UNITED STATES PATENT AND TRADEMARK OFFICE

APPLICATION NO.	FILING DATE	FIRST NAMED INVENTOR	ATTORNEY DOCKET NO.	CONFIRMATION NO.
09/894,787	06/28/2001	In Kap Kim	ORIEN22.001AUS	5977

Office Action Summary	Application No.	Applicant(s)
	09/894787	Kim et al.
	Examiner	Art Unit
	FORD	3743

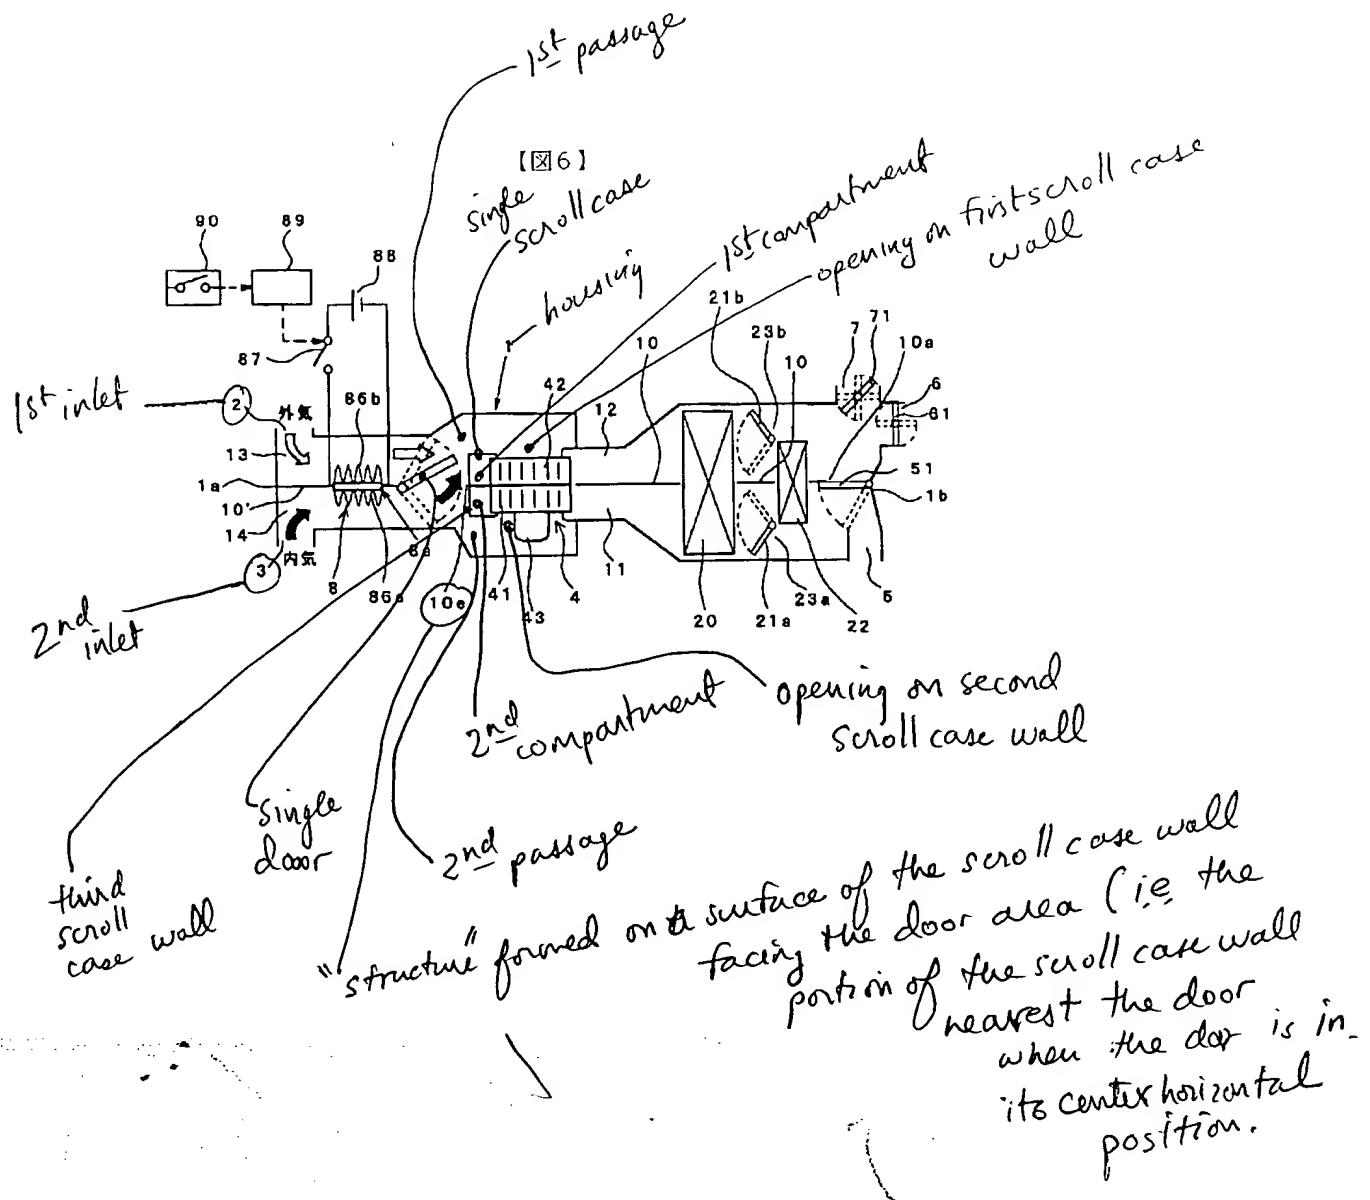
Claims 12-17 and 20-26 are rejected under 35 U.S.C. 102(b) as being anticipated by JP 9-254630.

See Figure 6 below. The "structure" recitation of claim 12 can, by applicant's disclosure, be a wall 27 (Figure 2) or a notch 27 (Figure 9). In the Examiner's reading of JP 9-254360, the "structure" recitation of claim 12 is met by the portion of the fan scroll casing that it at the terminal end of the lead line denoted 10e (i.e. the portion of the scroll case wall nearest the door when the door is in its center horizontal position)

F JP 60-8105
Figure 9
w/fan of JP 09-024723
substituted.

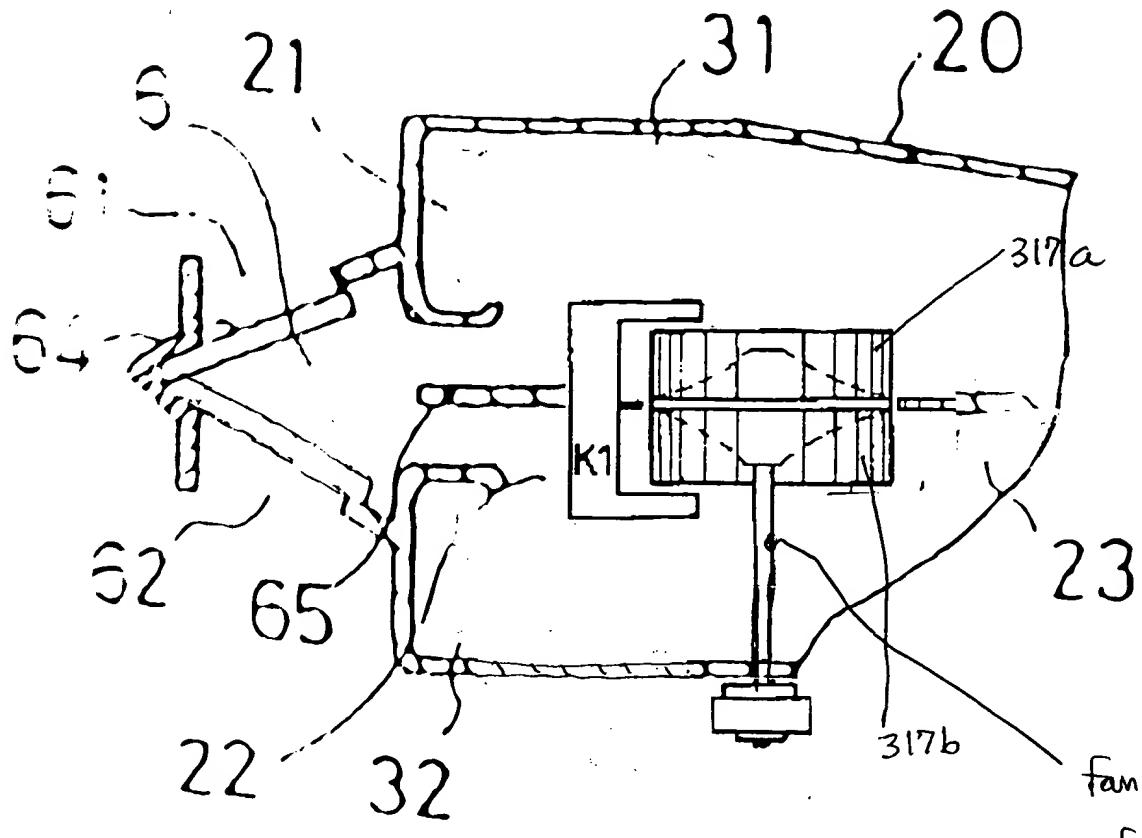
Claims 12-18 and 20-31 are rejected under 35 U.S.C. 103(a) as being unpatentable over the combined teachings of JP 60-8105 (Figure 9) and JP 09-024723 (Figure 13).

To have replaced the spaced apart blowers 31 and 32 of JP '105 (Figure 9) with a single scroll blower with two blowers 317a and 317b mounted together would have been obvious. See illustration below.
